Development Services

APPEAL SUMMARY

Appeal ID: 16549	Project Address: 3714 SW Macadam Ave	
Hearing Date: 2/28/18	Appellant Name: Jeancarlo Saenz	
Case No.: B-005	Appellant Phone: 9727269400 x106	
Appeal Type: Building	Plans Examiner/Inspector: Maureen McCafferty	
Project Type: commercial	Stories: 8 Occupancy: R-2, M, S-2, A-3 Construction	
	Type: Type I-A & Type III-A	
Building/Business Name: Block 40	Fire Sprinklers: Yes - Thorughout	
Appeal Involves: Erection of a new structure	LUR or Permit Application No.: 17-110666-LU	
Plan Submitted Option: pdf [File 1]	Proposed use: Multifamily residential and retail

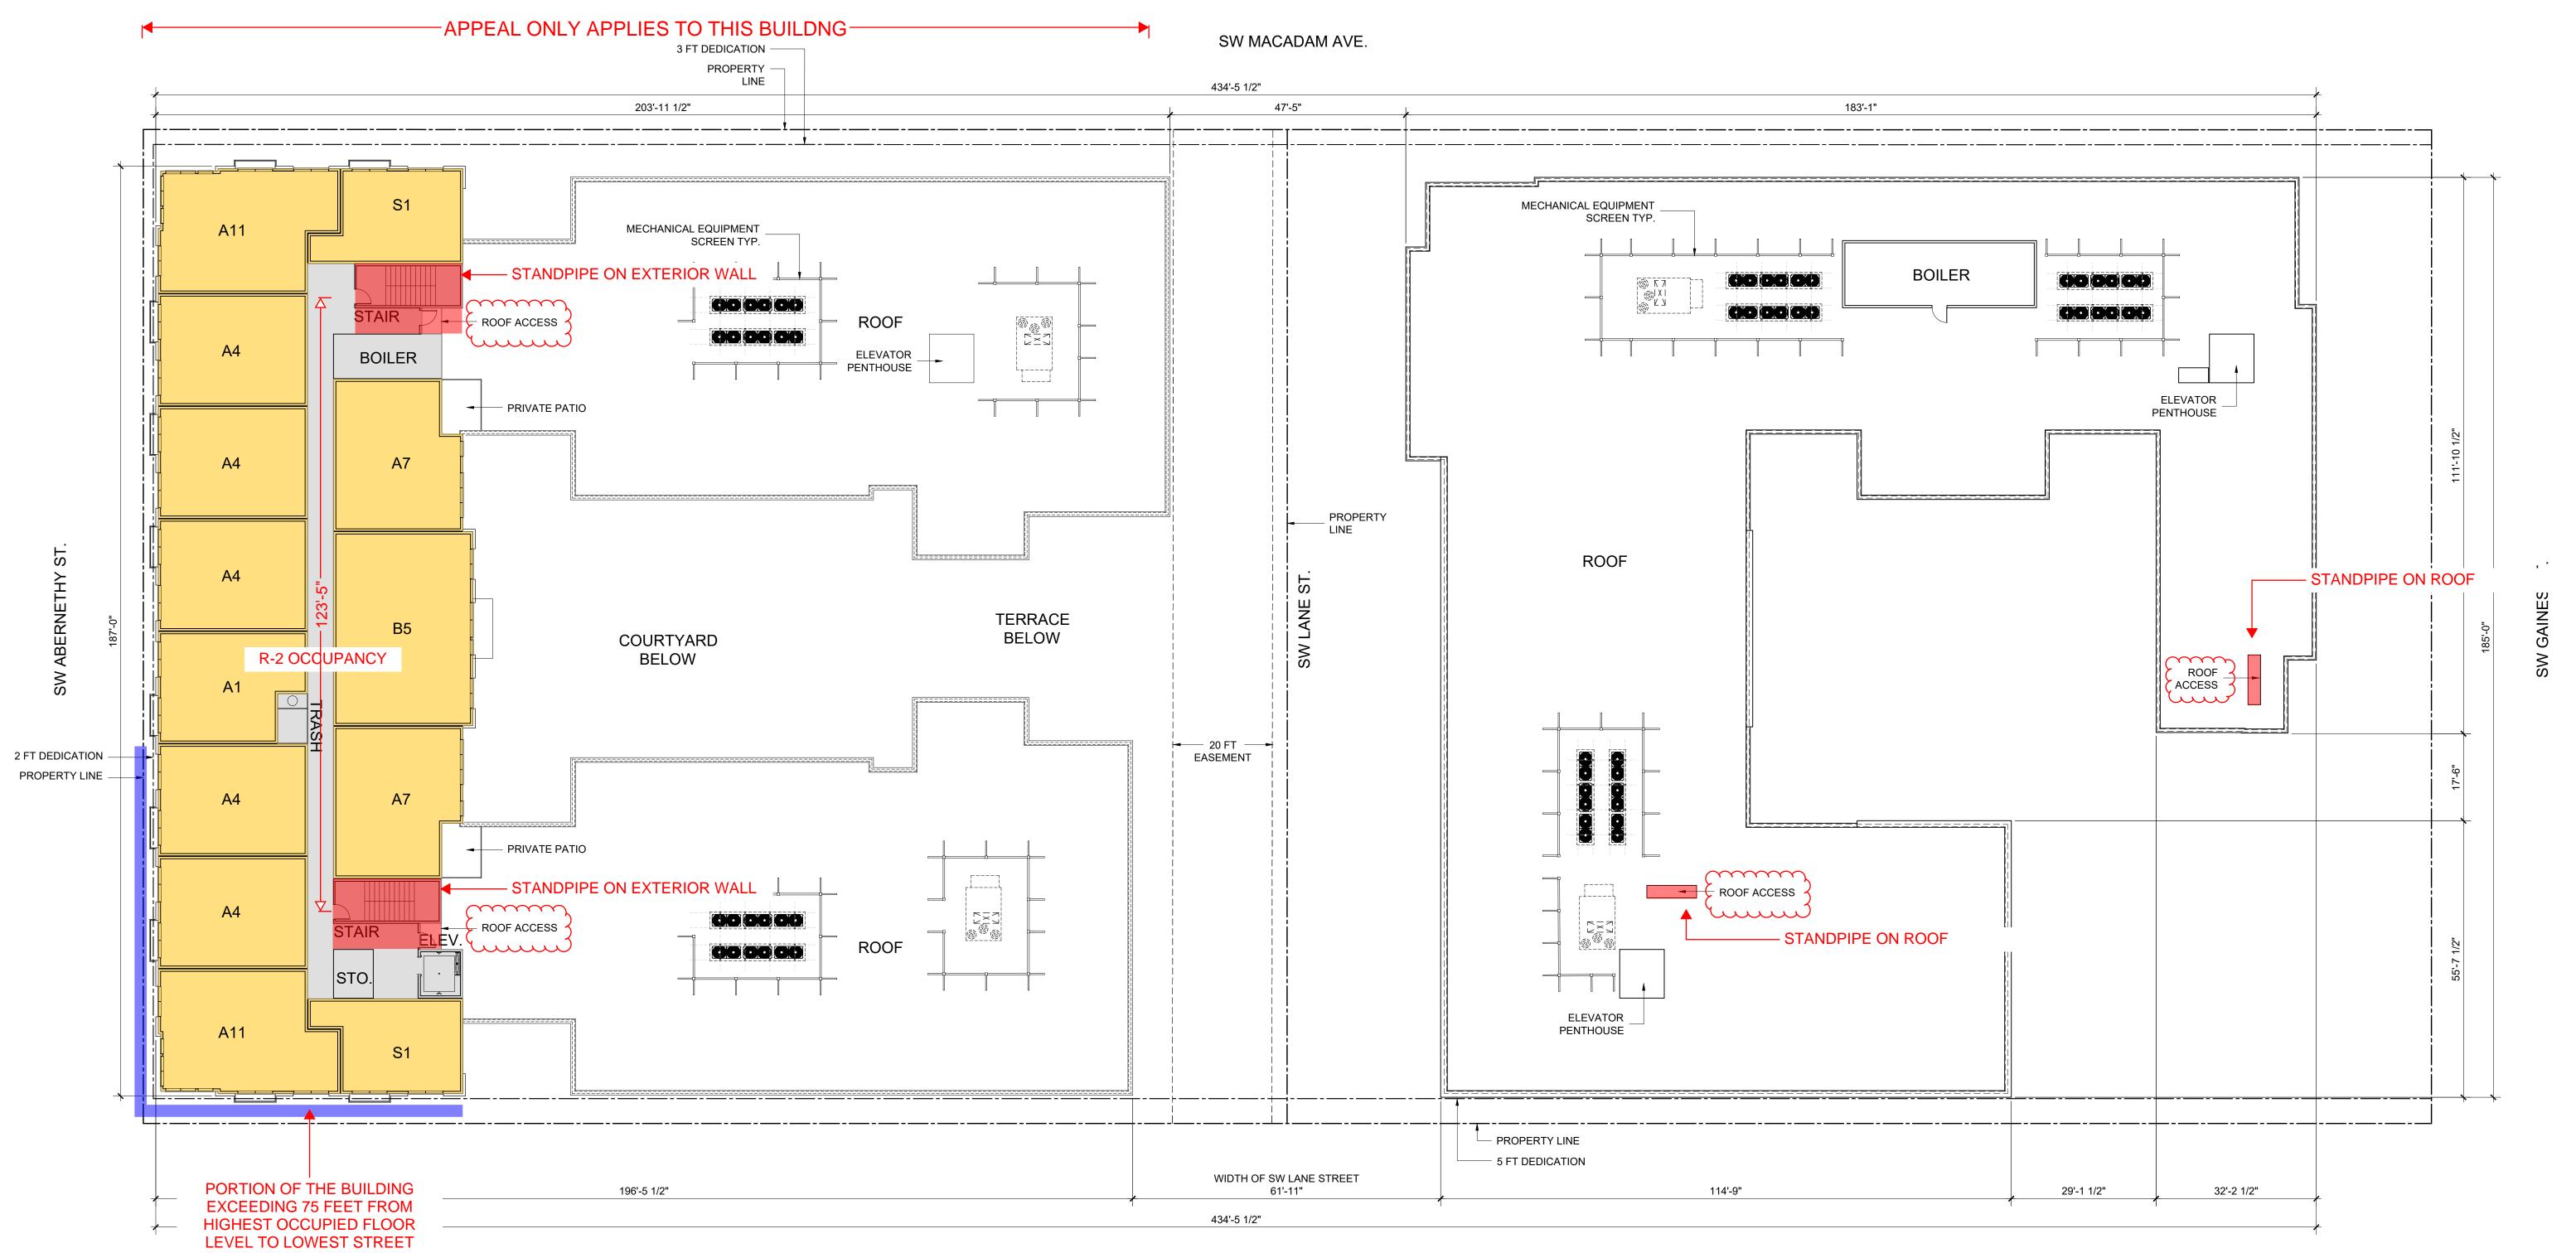
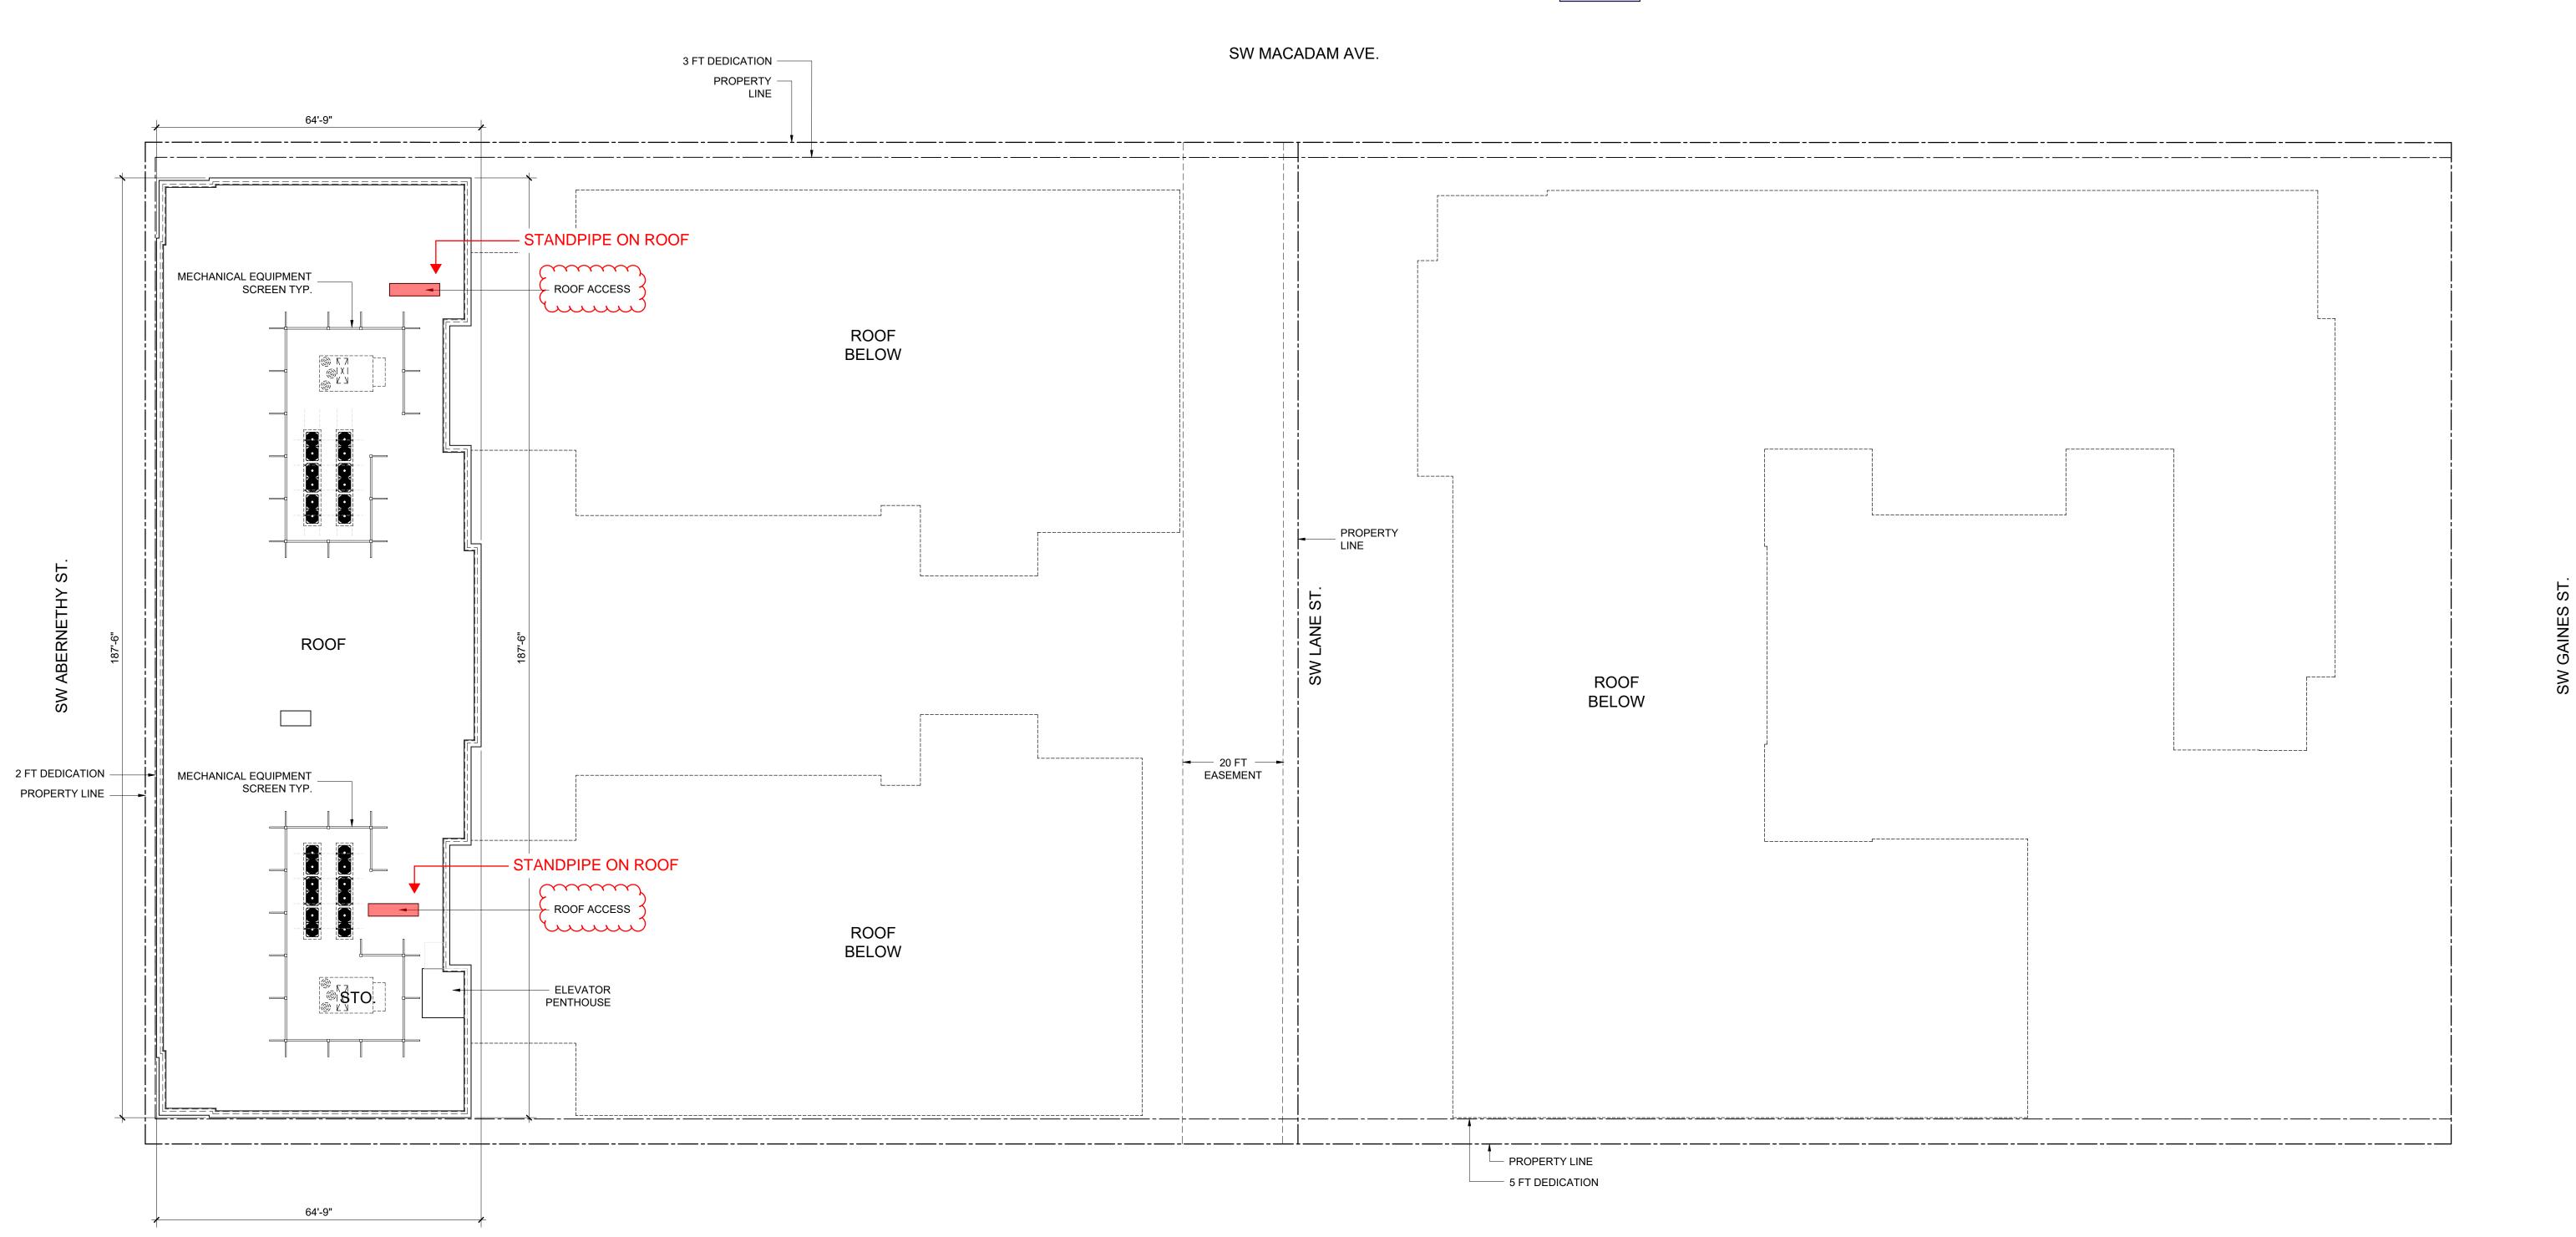
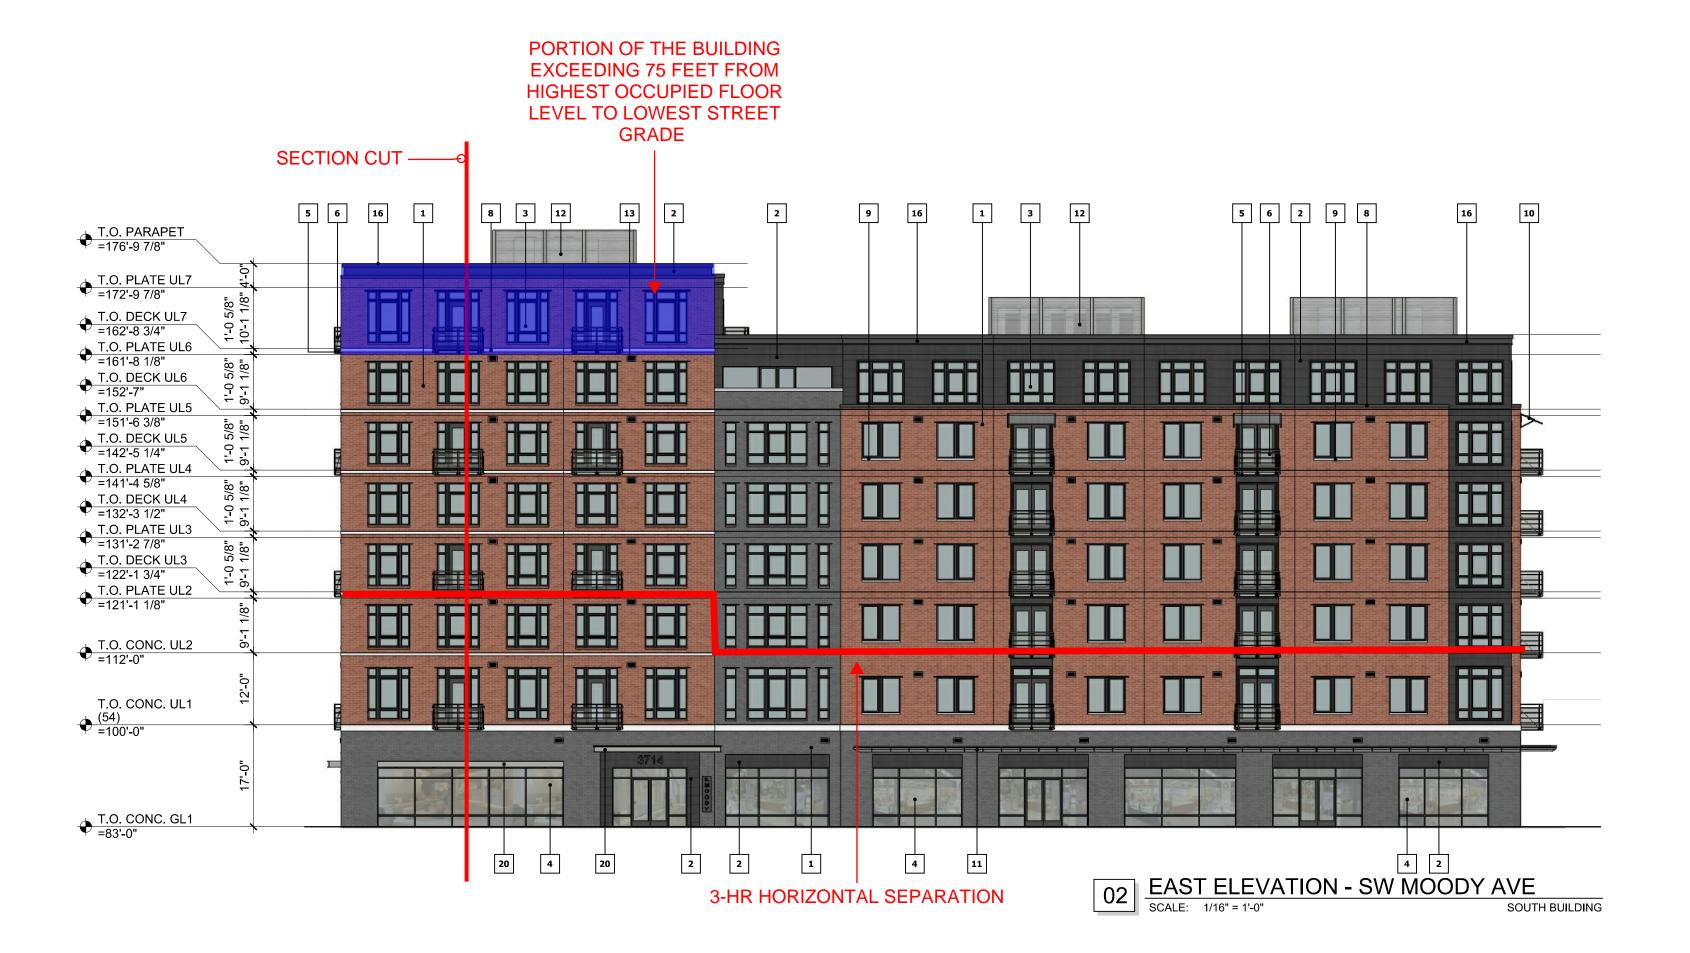
Attached exhibit shows the site layout with a section thru the building that shows how the added stories are determined and that we are still in compliance with the 85' height limit and the maximum number of stories above the separation

- Increase from 1 story to 3 stories of Type IA construction below the 3 hour horizontal separation: Granted provided all provisions of 2015 IBC are met.
- 1a. Vertical offset of horizontal separation per 2018 IBC: Granted as proposed.
- 2. Omission of high rise requirements: Denied. Proposal does not provide equivalent Life Safety protection.
